Markup Summary

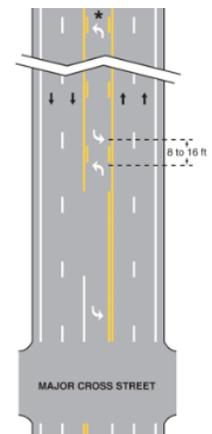
1. Identify the required left-turn lane length along Legacy Drive.
1. North of Moose Meadow the median turns to the splitter island TWLT is not appropriate.
2. The distance between Gulch Dr and Big Johnson Drive is only 450'. Required deceleration for a non-residential (40mph) is 315 plus required storage length. Analyze and provide a specific bullet item recommendation for this section. Is there potential conflict whereby a back to back left turn should be installed instead. If the TWLT is sufficient, it seems a channelizing white stripe should be used at the intersection. Per the snippet above what is the appropriate length for the channelizing line and the gap.

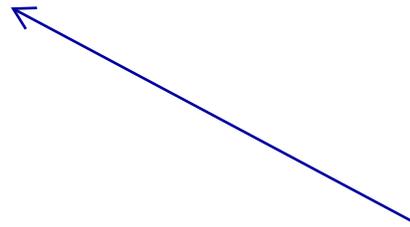
See ECM B.2.3 for the limits of the study area. Extend the study area to Marksheffel if it meets the threshold. If not, provide a statement justifying why offsite intersection was not included in the study. Reference the relevant criteria and identify the percent impact the project contributes to the intersection as part of the justification.

Explain why roughly a quarter of the traffic would head east. What is or are the destination(s) that would result in this percentage heading east.

Update the trip distribution narrative to explain why 24.5% is assumed. This seems high. It seems more convenient to use Powers to go south.
